**From:** John M. Bowman <JBowman@elkinskalt.com>  
**Sent time:** 06/01/2020 11:45:38 AM  
**To:** Craig Bullock <craig.bullock@lacity.org>  
**Subject:** FW: Comments on DEIR for Hollywood Center (Case No. ENV-2018-2116-EIR)  
**Attachments:** DEIR Comment Letter.pdf

**From:** John M. Bowman  
**Sent:** Friday, May 29, 2020 7:48 PM  
**To:** mindy.nguyen@lacity.org  
**Subject:** Comments on DEIR for Hollywood Center (Case No. ENV-2018-2116-EIR)

Re: Case No. ENV-2018-2116-EIR  
Project name: Hollywood Center Project  
Comments on Draft Environmental Impact Report

Figure 1 – Veneklasen Receptor Location Map

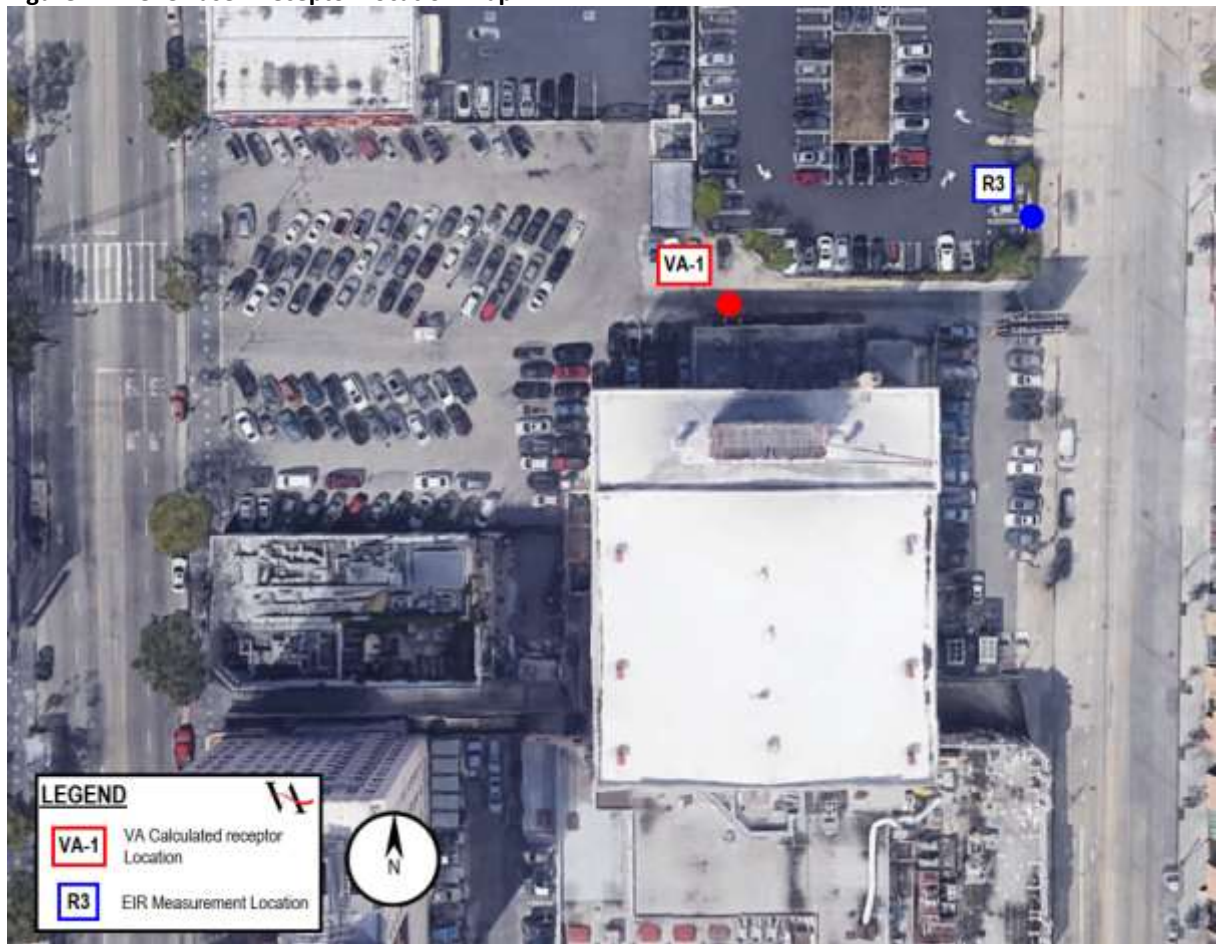
Draft EIR Page IV.I-21, Table IV.I-5: The measured noise level at measurement position R3 is not representative of the noise levels at the back of the Pantages Theater. The measured ambient level for the Pantages Theater indicated in Table 1, Appendix K-2 states that the measured level is 60.1 dBA at R3 along Argyle Avenue. This is not representative of the sound levels in the access alley behind the theater where there is some exposure to Vine Street, but also significant acoustical shielding because of building geometry which does not appear to be accounted for. Veneklasen performed a distance and angle attenuation analysis at Veneklasen receptor location VA-1 which is shown in **Figure 1**. Using the measured level at R3 along Argyle Avenue and the measured level at R2 on Vine Street, Veneklasen calculated the ambient noise level at VA-1 to be approximately 56 dBA, accounting for increased distance and reduced angle of exposure. As such, the significance thresholds identified in Table IV.1-19 and Table IV.1-10 for the Pantages Theater (receptor location no. 9) are significantly higher, which has the effect of understating the impact of construction noise on the Pantages Theater. Additional sound level measurements should be performed of suitable duration to determine the ambient levels in the alley behind the Pantages Theater. Veneklasen would suggest a minimum measurement duration of 72 hours during normal weather conditions.

Additionally, once the subject project is constructed, the alley behind the Pantages will be completely shielded from Vine Street, and the angle of exposure to traffic noise from Argyle Avenue will be further reduced, likely causing the noise levels to decrease further. Veneklasen estimates the post-construction ambient noise level in the alley behind the Pantages Theater to be approximately 47 dBA.

**Figure 2 – Background Music Distance Attenuation Locations**

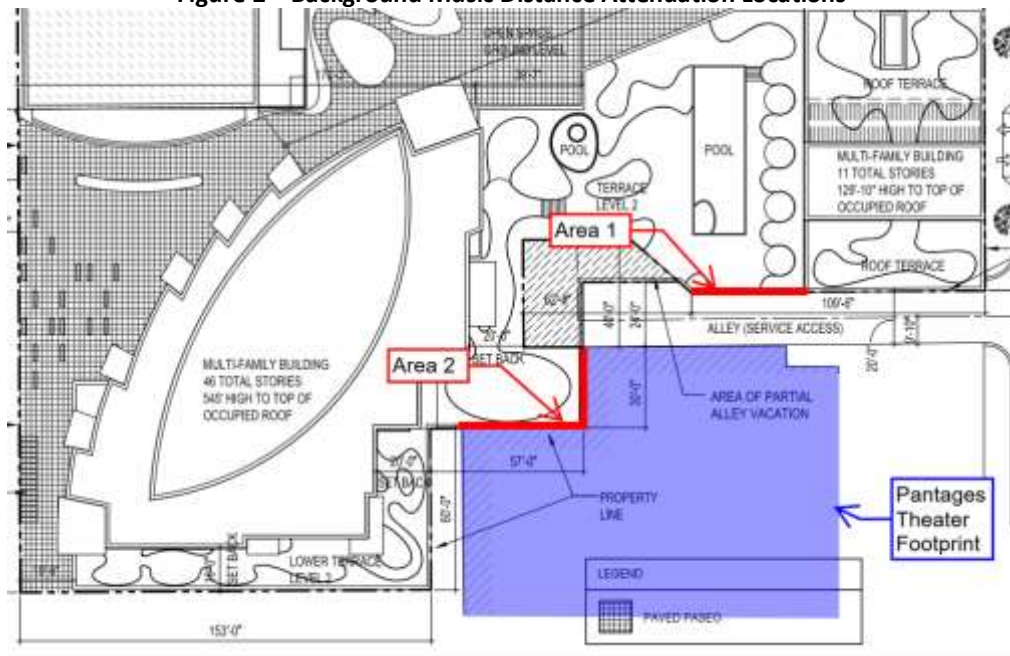
Draft EIR Table IV.I-12 and Page IV.I-51: On page IV.I-51 it is stated that the “sound level of the music speakers is conservatively assumed to be 75 dBA at 25 feet, which is more than 5 dBA higher than the ambient noise levels in the vicinity of the Amenity Deck (Level 2), East Site, which ranges from approximately 60.1 to 68.3.” The predicted noise level pre-construction is 56 dBA and as stated in **Item I** above, Veneklasen predicts the post-construction noise level from Argyle Avenue to be about 47 dBA. Both predicted pre-construction and post-construction noise levels are significantly lower than the assumed 60.1 stated in the Draft EIR indicating that additional review and analysis should be performed. The areas from which Veneklasen performed a distance loss calculation between the Amenity Deck (Level 2), East Site and the Pantages Theater are shown in **Figure 2** below:

The distance from Area 1 to the Pantages Theater is 20 feet and the Distance from Area 2 to the Pantages Theater is 0 feet. For the purpose of an accurate analysis, Veneklasen has assumed a minimum distance of 5 feet from the nearest music speaker for Area 2. The results of these calculations are shown in **Table 3** below:

Figure II-19 indicates that under the East Site Hotel Option, there will be a swimming pool located in Area 2 is as shown in **Figure 2** above. Using the same calculation methods to determine the sound levels from speech at the Pantages from this area, the noise level will be 80 dBA at the Pantages. This would be a significant on-going impact and this area cannot be occupied by a pool, as any operation will significantly exceed both proposed interior noise guidelines and could negatively impact rehearsals and other theater operations.

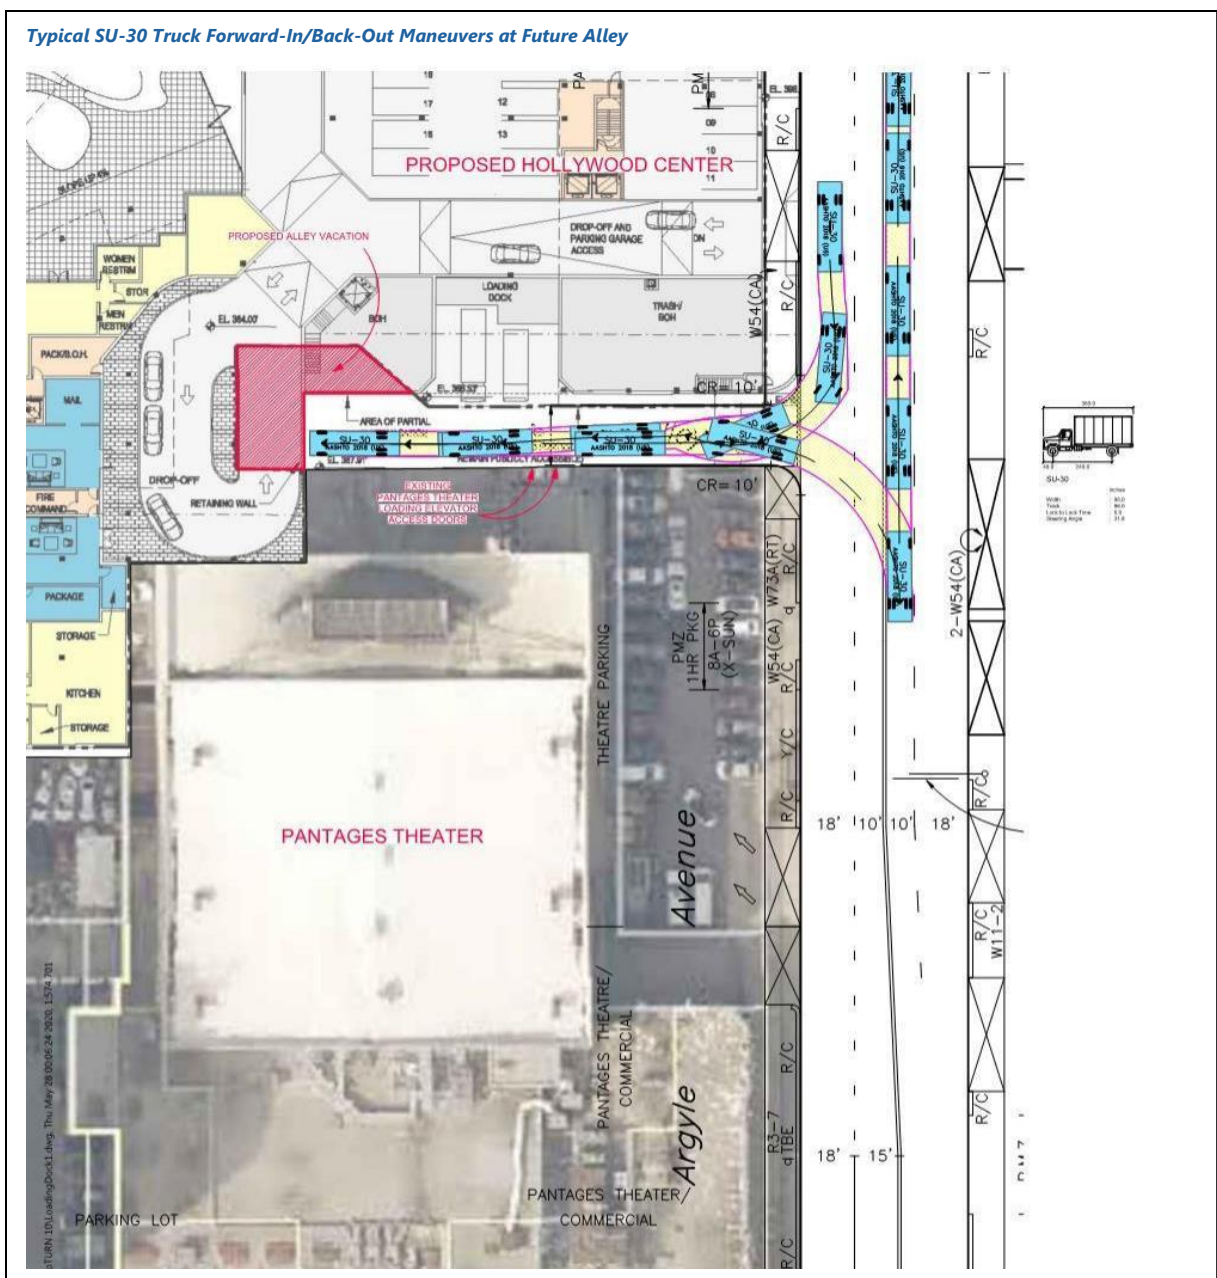
Project Site Plan as exhibited in the TA contains conflicting information. Particularly, the alley shared between the Project and the Pantages Theatre are shown differently in Figure 2A and 2D. Figure 2A, the Site Plan capturing both the East and the West Sites, shows the alley with the turnaround area left intact between the two sites. Conversely, Figure 2D, also labeled as the "Site Plan", represents a close up of the East Site, and shows a portion of the alley being vacated and thus eliminated the turnaround capability.

Figure 2D, which indicates that Project drop-off/pick-up area will occupy the vacated portion of the alley, is consistent with Figure II-14 in the Description of Project section of the DEIR, which indicates that this vacated portion of the alley is to have walls constructed separating it from the remaining alley, thus creating a dead-end condition for the shared alley with no turnaround space for service trucks. The alley turnaround area is currently used for daily delivery trips by the Pantages Theatre, trash pickups, and other services, and needs to remain usable without impedance. Under the existing conditions, standard single-unit trucks (SU-30) can utilize the turnaround area to depart without having to back out of the alley:

Under the proposed conditions, a typical SU-30 truck will no longer be able to turn around in this dead-end alley, and must back out of the alley driveway in order to depart, thereby adding even more truck movements on Argyle Avenue. Below is a typical scenario in which a SU-30 truck would have to maneuver in order to arrive and depart the alley:

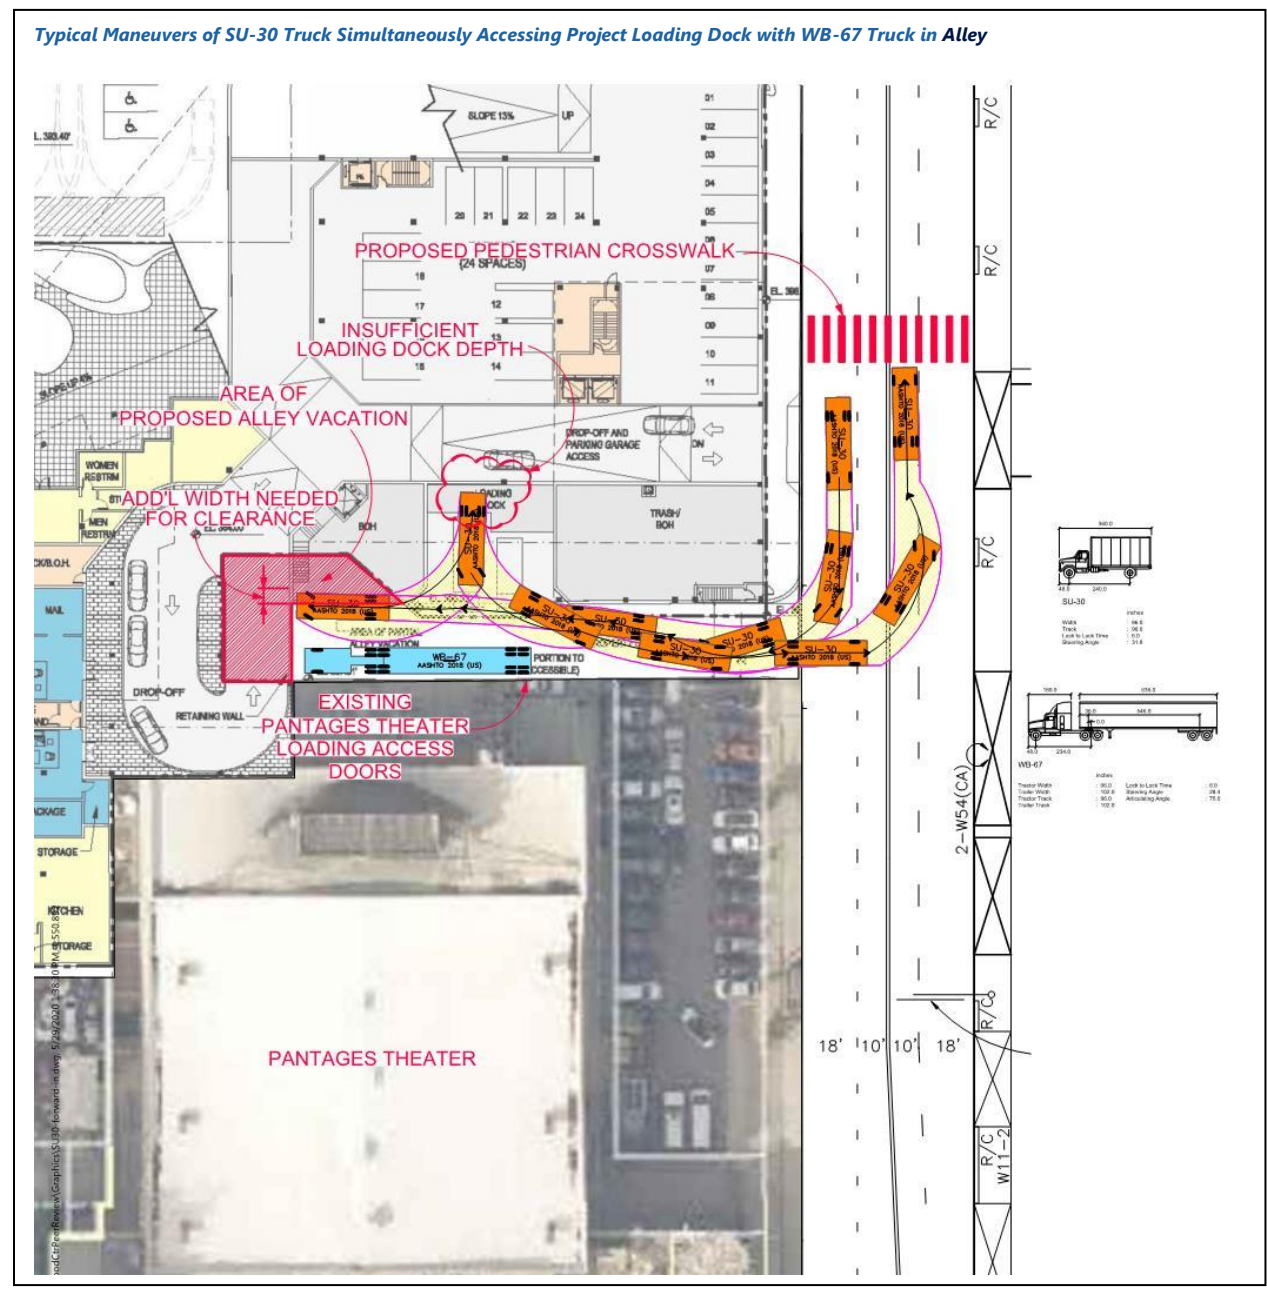
The safety concerns of requiring daily delivery trucks for the Pantages and other south side users of the alley to now back out rather than turn around needs to be analyzed and fully addressed. The analysis needs to consider having the trucks back up past the Pantages elevator and other alley activities, across the

Further, when trucks serving the Pantages Theatre occupies a portion of the currently proposed alley for loading and unloading, the Project loading dock is rendered inaccessible, as it does not have sufficient depth to accommodate the simultaneous uses that can occur within a shared use alley such as this one. An example of such a condition is shown below:

As shown above, in order for a SU-30 truck to access the project loading dock while a semi truck is positioned in the alley, additional width is needed in order for the su-30 truck to bypass the WB-67 semi

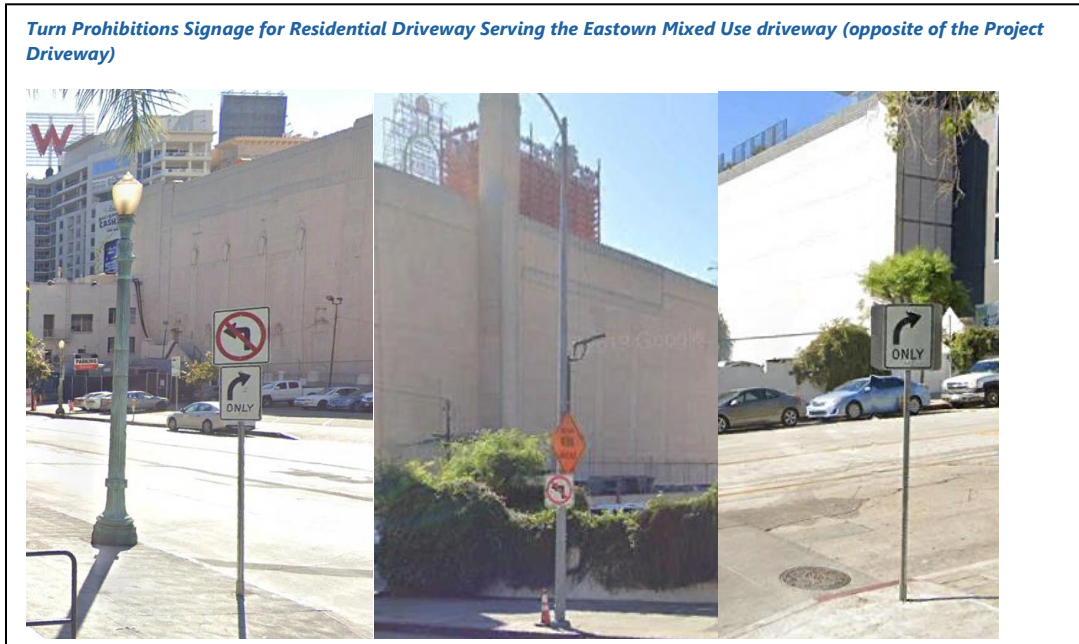
The mid-block pedestrian crossing proposed across Argyle Avenue is cited throughout the TA as a Project feature. However, the pedestrian crossing on Argyle is not characterized or analyzed as it is proposed – a crossing that is part of a four legged intersection, with two legs being private dust-pan style driveways, and with the Project driveway “daylighting” from a subterranean parking garage, which is essentially the terminus of a speed ramp. Based on the City of Los Angeles standards, dustpan-style driveways connecting the street do not receive a full traffic signal (red-yellow-green indicators). Instead, the City of Los Angeles Department of Transportation generally limit these types of intersections to receiving at most a “red flashing” indicators for the driveways, or install only devices for the pedestrian crosswalk. Unless both the Project driveway and the driveway serving the Eastown mixed-use development are flanked by step-down curb and radius designs, the signalization for this location would not typically be granted a full traffic signal operation. A pedestrian crossing immediately adjacent to and part of the same intersection containing a speed ramp from a subterranean parking structure presents limitations to visibility of a pedestrian crosswalk that is directly next to this speed ramp. The safety implications of the pedestrian crossing next to a subterranean ramp, rather than at a mid-block location, are not discussed nor analyzed. Further, the dust pan driveway design increases potential safety conflicts with pedestrians. Additionally, the dustpan configuration and sight distance concerns are further exacerbated by Argyle Avenue having an approximately 7% uphill slope north of the Project driveway. A more detailed safety analysis of this entire concept should be further studied.
